## CAUTION NOTICE MARCH 2024

Gasmizer System
SAECO Valve Middle Spring Pt No. V5230

GR-PCN-3

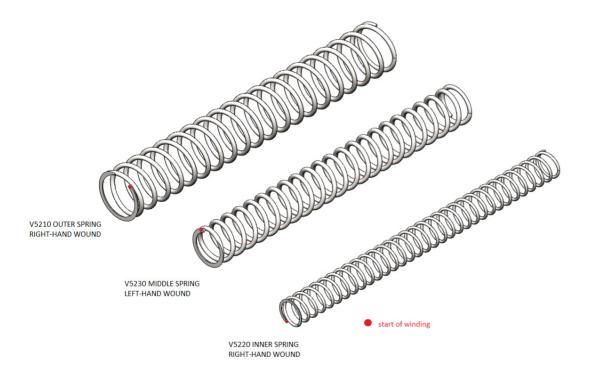
JFD have identified a batch of these springs that have been wound right-handed rather than left-handed. Because of this, it is possible that the middle spring could interfere with either the inner or outer springs (although the Teflon spacers should limit this). Any interaction between the springs could prevent the SAECO valve opening fully.

Users who have purchased replacement springs since August 2022 should inspect these springs at a convenient time.

Please see the images below for the correct winding direction of each spring.

JFD will replace any incorrect items.
